<b>AMENDMENT OF SOLICITATION / MODIFICATION OF CONTRACT</b>				1. CONTRACT ID CODE		PAGE OF PAGES 1 4	
2. AMENDMENT/MODIFICATION NO. 4		3. EFFECTIVE DATE 3-2-89		4. REQUISITION/PURCHASE REQ. NO. ADM-88-173		5. PROJECT NO. (If applicable)

"C.5      Special Requirements in the NRC Phillips Building Complex

PROCEDURES FOR INSTALLATION OF SIGNAL CABLE IN  
THE PHILLIPS BUILDINGS, 7900 AND 7920 NORFOLK AVENUE  
BETHESDA, MARYLAND

UNITED STATES NUCLEAR REGULATORY COMMISSION	
1910 NORTON AVENUE, BETHESDA, MARYLAND	
DATE: 10/20/88	BY: [Signature]
FOR: [Signature]	REVISION: [Signature]
GUIDELINES FOR SURFACE MOUNTING SIGNAL CABLE INSTALLATION.	
1 OF 1

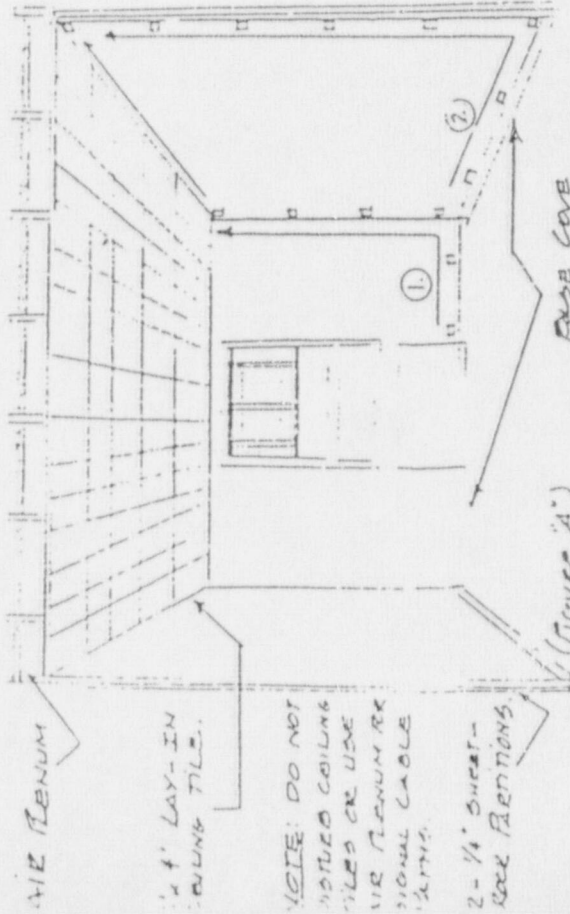
1. All signal cable shall be surface mounted along the lower wall partitions inside office areas and proceed to the rear or the front of the office and then proceed to the top of the wallboard (see Figure A, 1 and 2).
2. Plastic molding strips shall be used to secure the signal cable to partitions (see Figure A, Reference 1).
3. Exit cable through drywall near ceiling tiles and continue run to destination(s) along corridor as shown in Figure B, #4.
4. Should a cable run involve crossing a corridor, run the cable along the ceiling grid and secure with plastic molding conduit and/or rings located just below the ceiling tiles.
5. These procedures shall be performed in the presence of an NRC inspector.
6. The contractor shall provide all plastic molding conduits and/or rings.

- 0- PLASTIC MOLDING STRIPS.  
 SIZE: 1" WIDE X 1 1/2" HIGH X 1/2" DEEP  
 SHAPE: SEMI-CIRCULAR WITH FLAT  
 ADHESIVE BACKING.  
 SPACING: APPROXIMATELY 4' APART.
